INSTRUCTION TO SERVICE

ITS: 59076	
SECTION:	273 Exterior Lights
WRITTEN BY:	Mike Pearson
SUBJECT:	Replace specified street and curbside front headlamps

Figure 1: Headlamp Date Code and Hole Locations, Typ for CS & SS

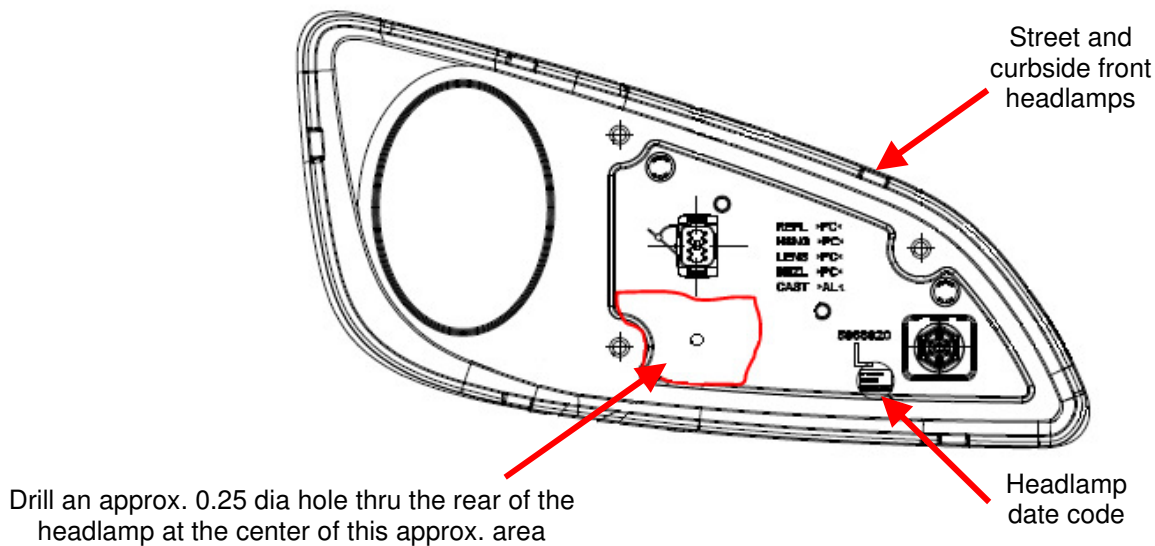
3. Inspect the date stamp on the existing curbside and street side headlamps, an inspection mirror may be needed to view the date stamp location, see Figure 1 for date stamp location.

11. Turn the main battery disconnect switch to the "ON" position.
12. Removed headlamps, failed or not must have the headlamp date code documented for each claim (headlamp) to be accepted, as well as an approx. 1/4" dia hole is to be drilled thru the rear of the headlamp to an approx. depth of 1/2". The date code and hole can be located as shown;

4. If the headlamp date stamp is between 26-June-2019 and 14-October-2020 the headlamp will need to be replaced as per Steps 5 thru 8, **document and discard the headlamp as per Step 12**. If the headlamp date stamp is not between 26-June-2019 and 14-October-2020 the headlamp is not to be replaced.

5. Disconnect tie back the harness from the headlamp being replaced.
6. Remove and save the existing headlamp mounting hardware.
7. Remove the existing headlamp and install the new curbside headlamp p/n 621840 and/or street side headlamp p/n 621841 depending on date stamp using the existing hardware from Step 6, torque hardware to 40-50 in*lbs. Headlamp modules are to be centered in the pockets in the front mask to ensure that there is no contact between the headlamp and the panel.
